1984 Corvette: Service Bulletin: Side Door Lateral Movement

Subject: Side Door Lateral Movement
Model Year: 1984 Corvette
Source: Chevrolet Dealer Service Bulletin
Bulletin No: 84-118, Section: 10 (I)
Date: April, 1984

FIGURE 1

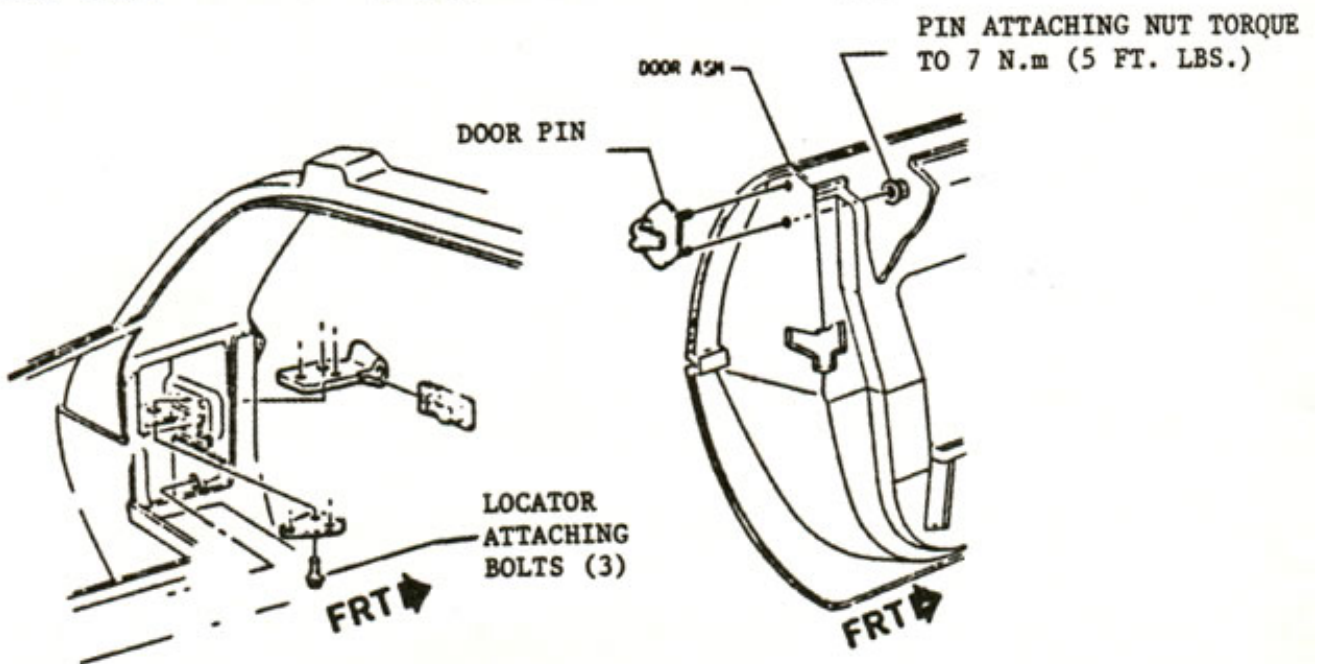
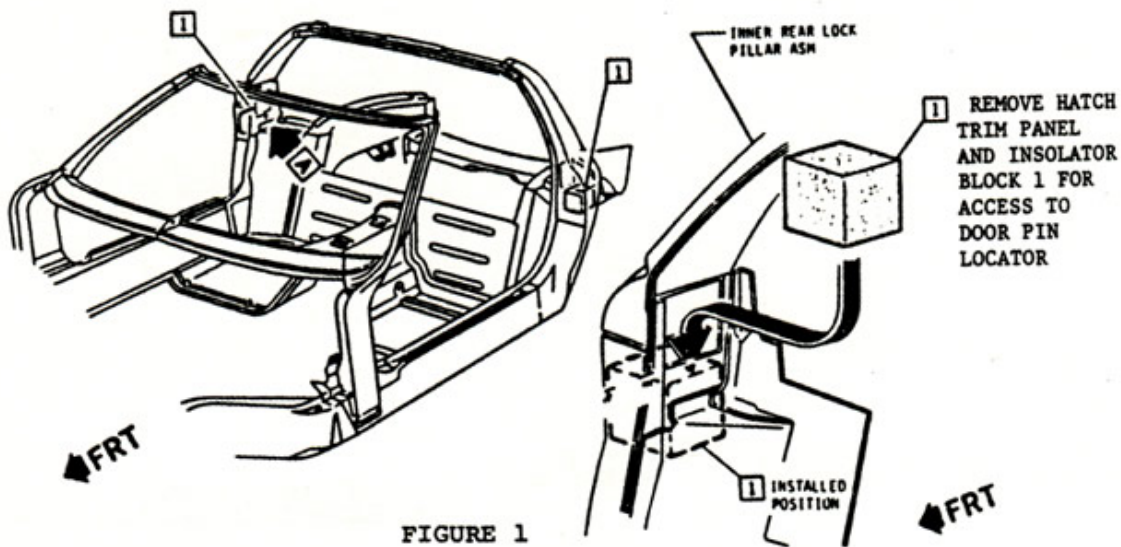
Verify the plastic sleeve is installed in the pin locator assembly. With the vehicle door closed, loosen the locator three (3) attaching bolts (see Figure 1). The locator assembly is to be centered fore-aft and vertically on the door pin. Push the locator outboard to fully engage the door pin and tighten the locator attaching bolts to 11 N.m (8 ft. lbs.)

FIGURE 2

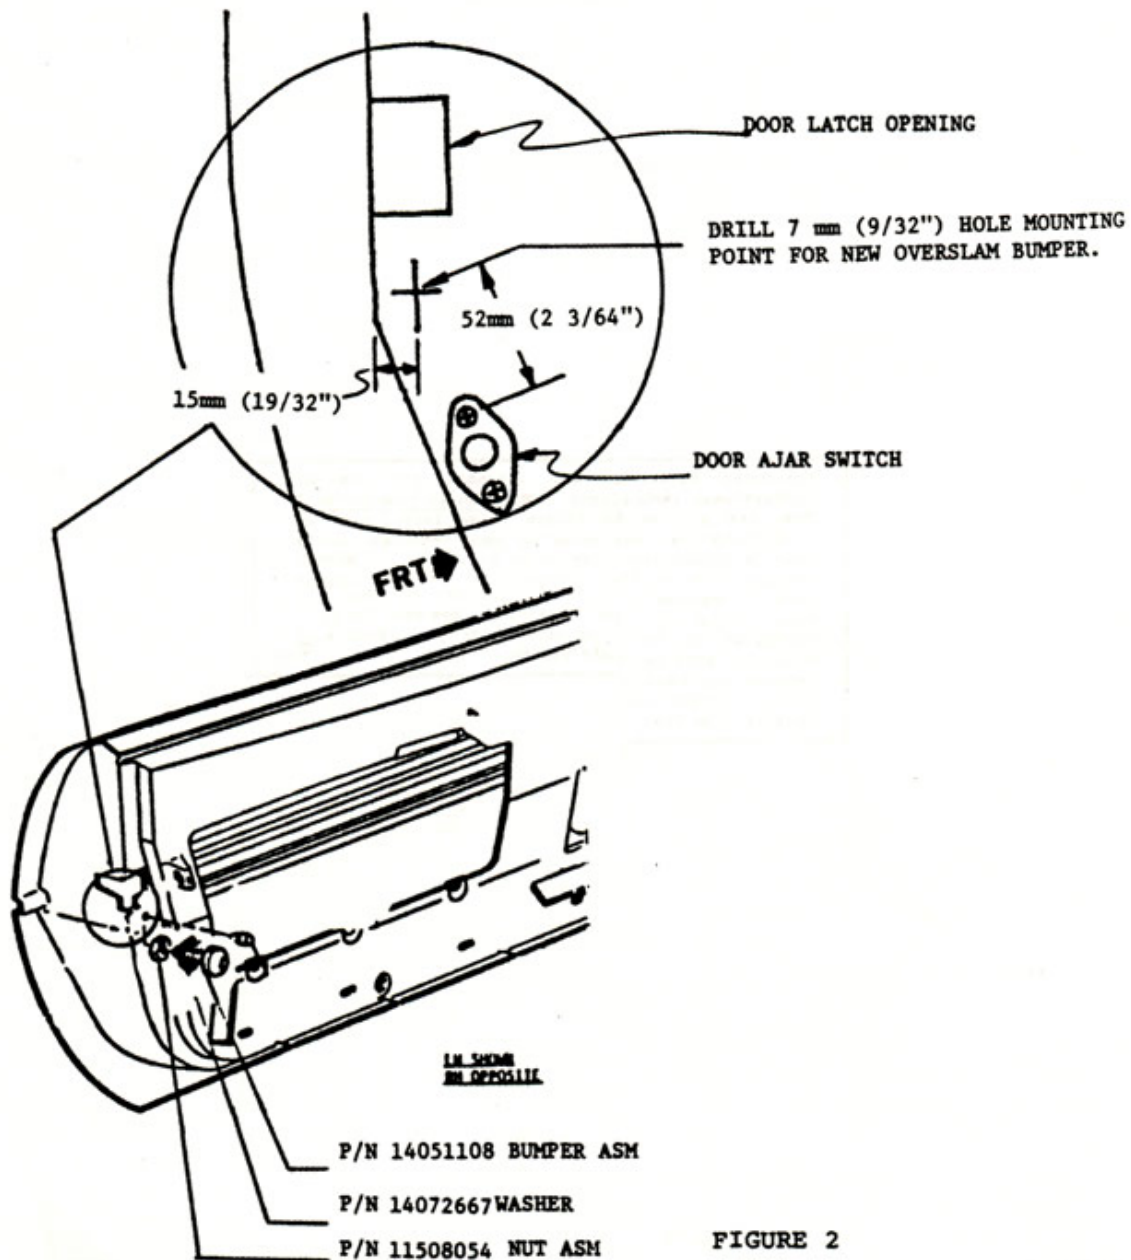
Some early built vehicles did not have overslam bumpers. If this is the case, it will be necessary to drill a 7mm (9/32") hole in the door (see Figure 2).

Add shims (washers) between bumper and door, as required, to eliminate lateral door movement (see Figure 2). DO NOT "OVERSHIM" BUMPER.

Replace the discarded production bumper(s) with bumper, P/N 14051108, attaching nut, P/N 11508276, and P/N 14072667, flat washers, which are to be used as bumper shims. The number of shims required will vary from vehicle to vehicle depending on "Build stacks".

Once shim pack has been established, tighten bumper retaining nut to 12 N.m (9 ft. lbs.) and check the door ajar lamp for proper operation. The door ajar switch is self-adjusting and cannot be reset.
